PROPOSAL FOR DRAFT AMENDMENTS TO REGULATION No. 48
(Operating voltage for lighting and light-signalling devices)

This document is a revised proposal from Germany. The modifications to TRANS/WP.29/GRE/2003/20/Rev.2 are marked in **bold** characters.

A. PROPOSAL FOR DRAFT AMENDMENTS TO REGULATION No. 48

Annex 9

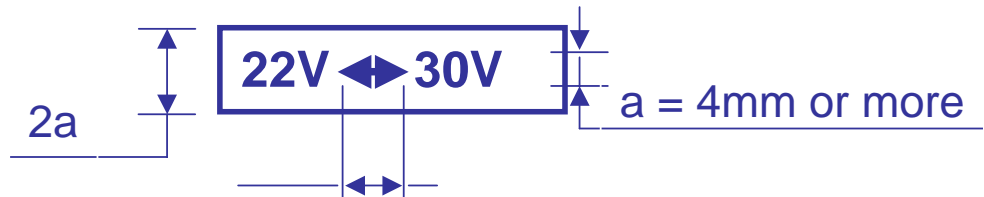
Add a new Annex 9, to read:

MARKING OF THE RANGE OF ENTRY VOLTAGES

This headlamp was designed for root mean square entry voltages ranging from 22 Volts to 30 Volts
